EVERSTEAD
SHOP DRAWINGS/SUBMITTAL REVIEW

JOB No.	2852320
DESCRIPTION	SUMMIT HOMES - STONEY CREEK #127 - 1ST LVL
JOB ADDRESS	1908 SW MERRYMAN DR
CITY	LEES' SUMMIT, MO 64082
DESIGNER	TODD W MOORE
DATE	7/1/2021

ROOF
TRUSS LAYOUT

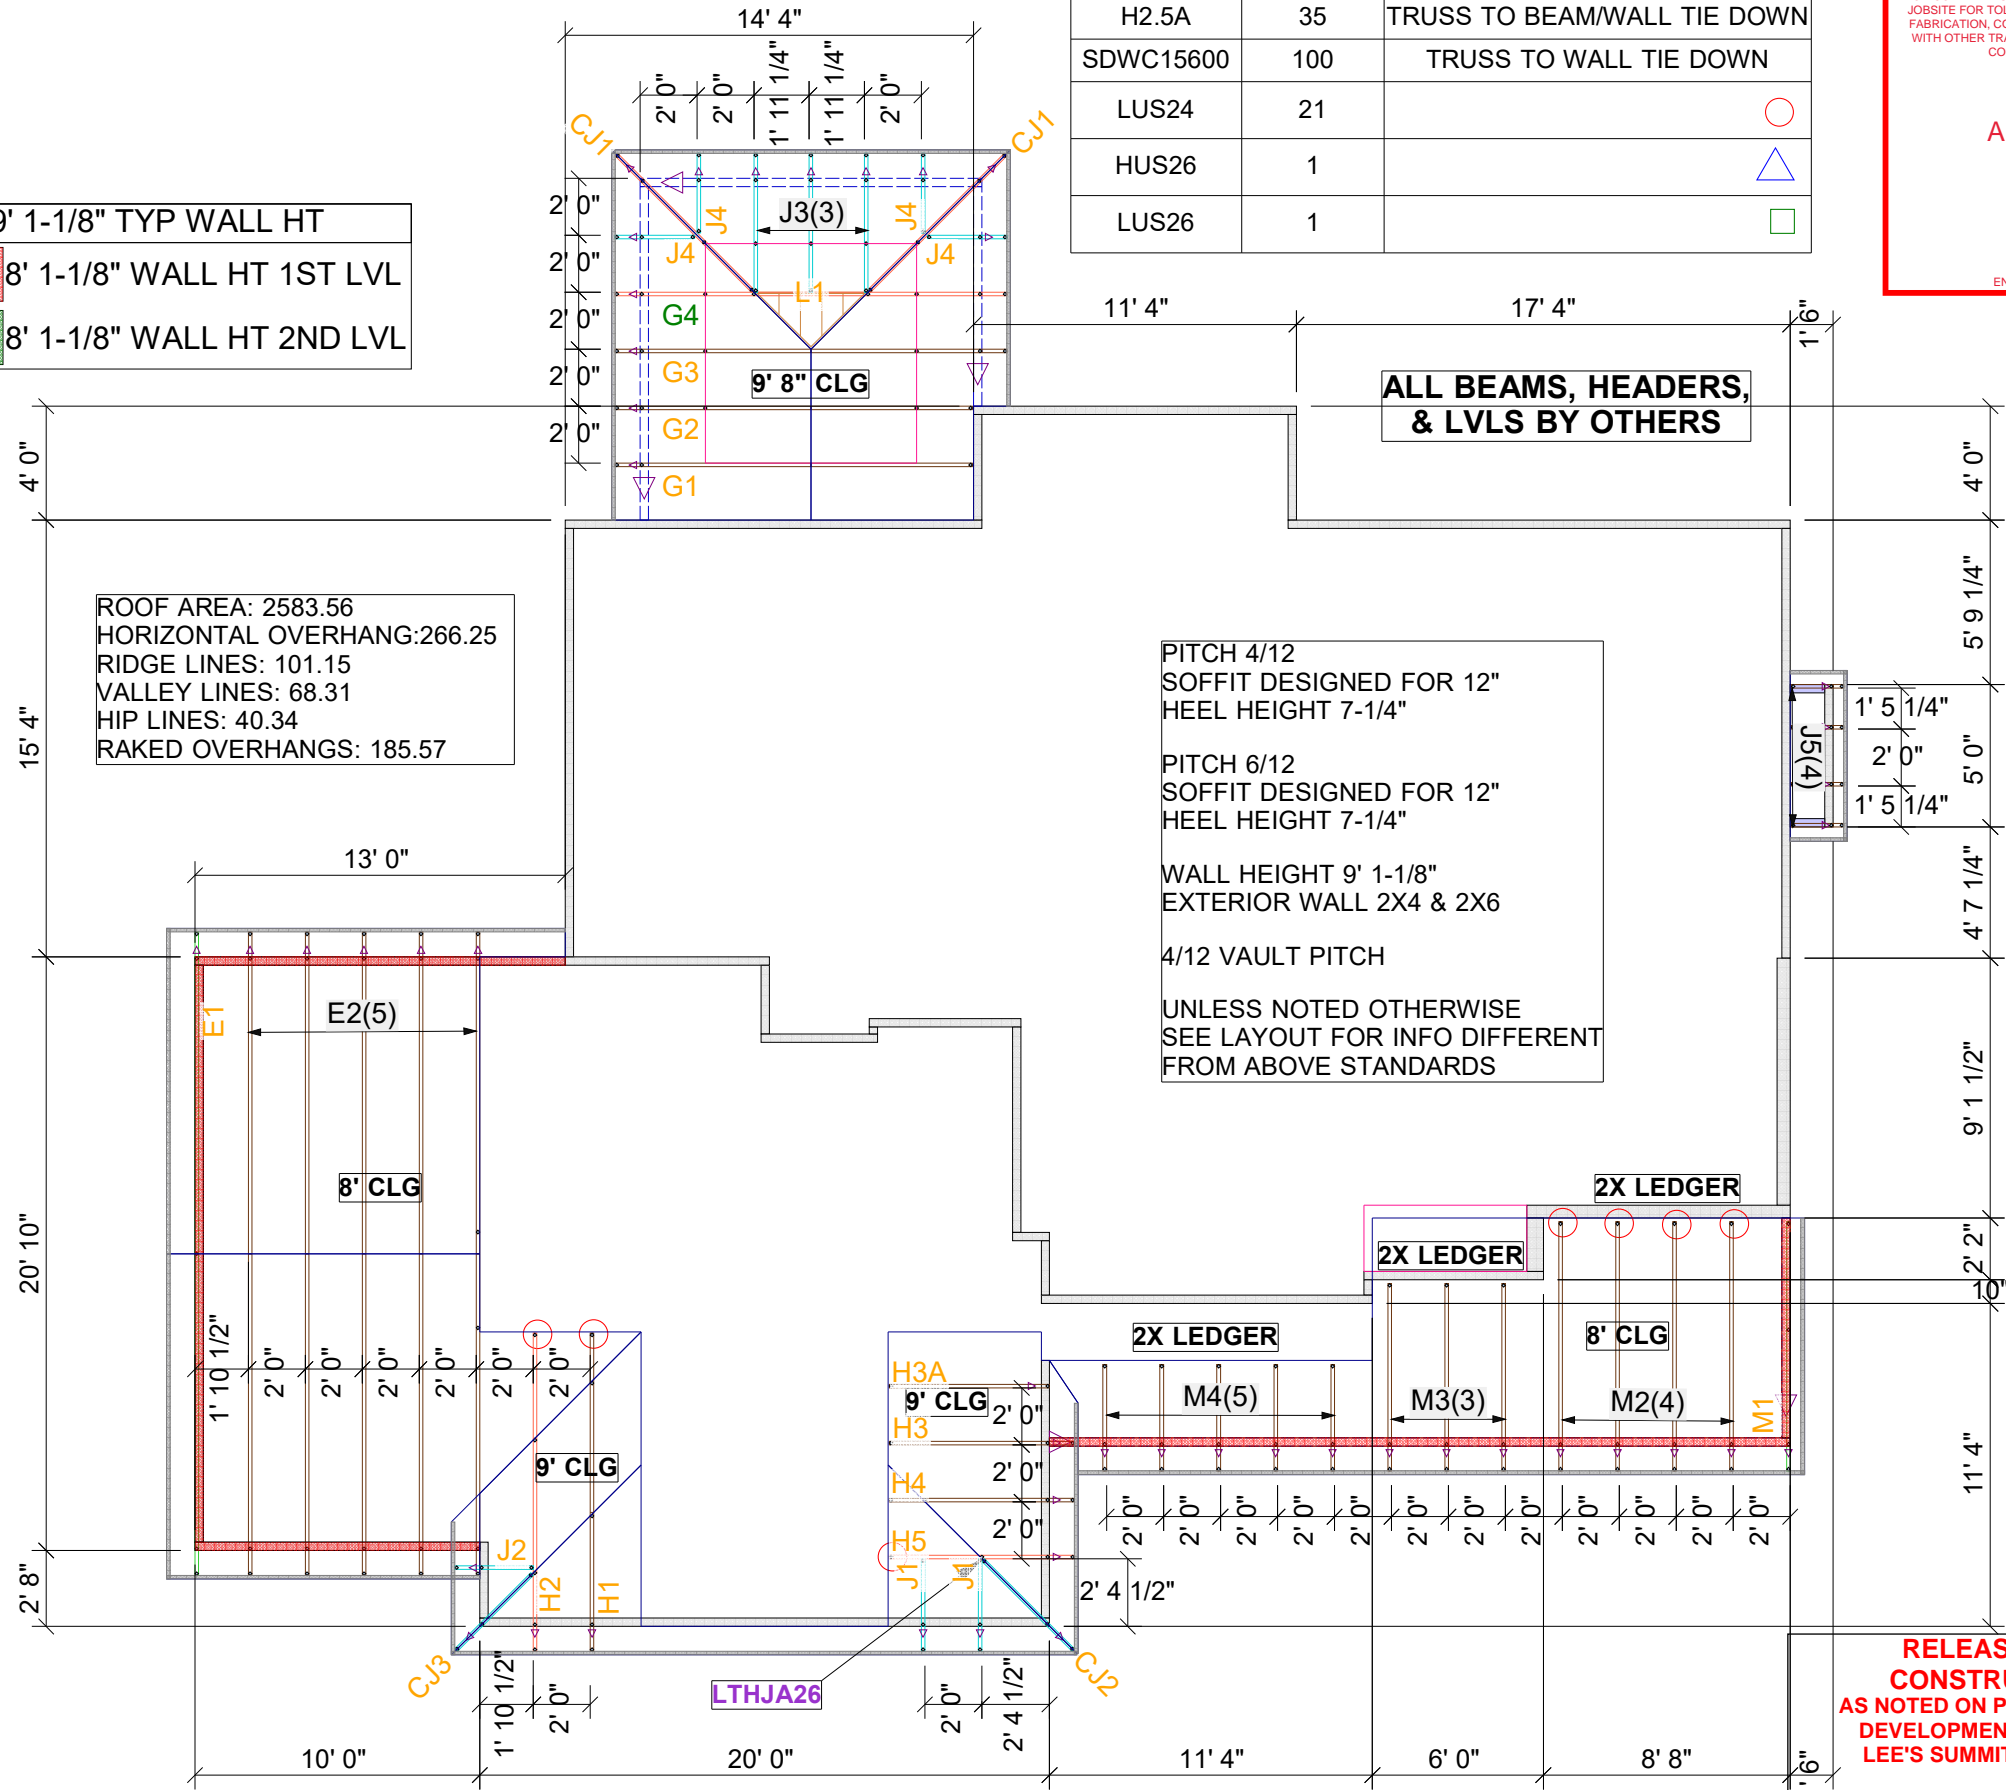
APPROVED
